ENGINE DISTRIBUTORS SERVICE BULLETIN

GX35NT • GX35T (GY5) FUEL STARVATION

OVERHEAD-VALVE ENGINE #52

JANUARY 2015

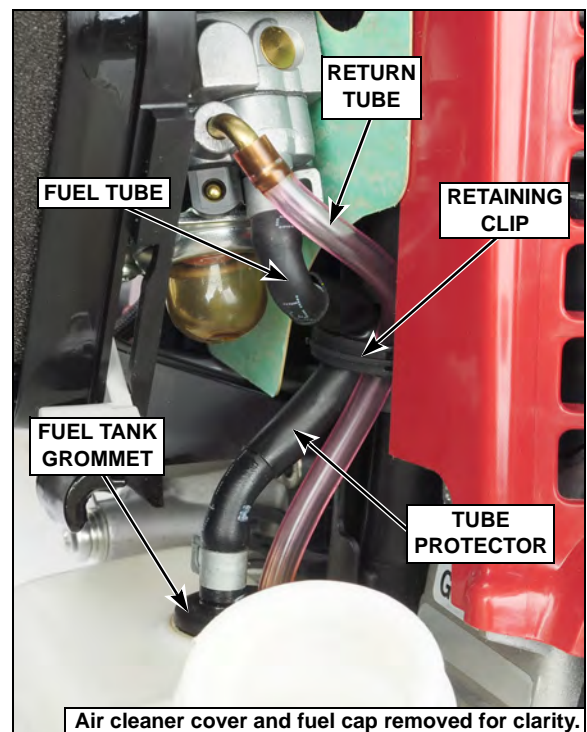
The fuel starvation is due to a kink in the fuel supply tube between the fuel tank and the carburetor. The fuel tube is too long, resulting in excessive bending and kinking of the tube where it passes through the fuel tube retaining clip.

To reduce the excessive bending at the retaining clip, replace the fuel tube and fuel tube protector following the procedure beginning on [page 2](#).

A new tube protector must be installed. The original tube protector can retain the shape of the original fuel tube and cause the new fuel tube to kink.

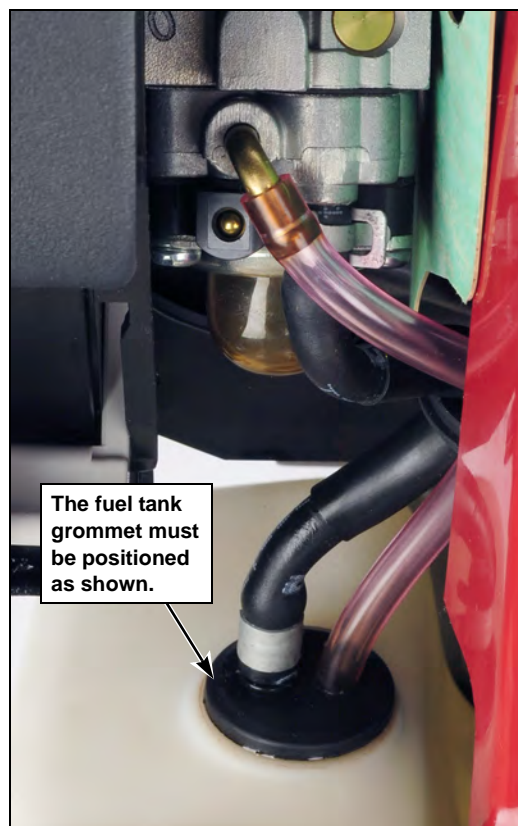
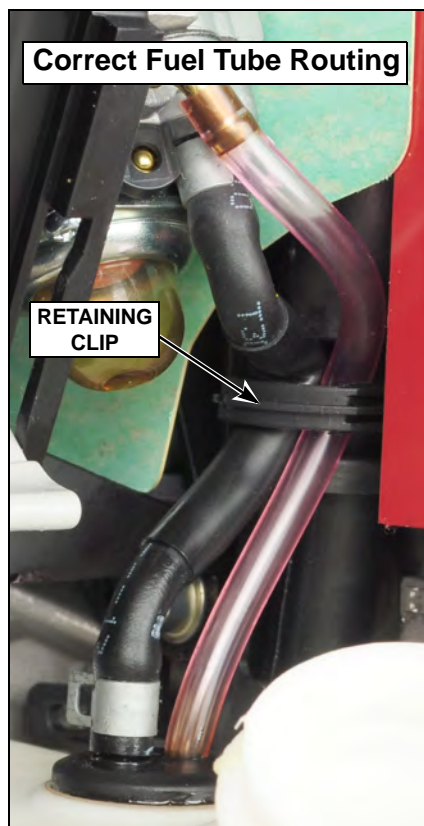
1. Slide a new tube protector over the new fuel tube to the position shown below. Do not reuse the original tube protector.

2. Remove the existing fuel tube from the engine and then install the new fuel tube assembly. The end of the fuel tube with short 90 degree bend goes towards the carburetor. Position the fuel tube so it goes in towards the retaining clip. Route the return tube and fuel tube through the retaining clip. To ensure proper fuel tube routing, the fuel tank grommet must be positioned as shown below.
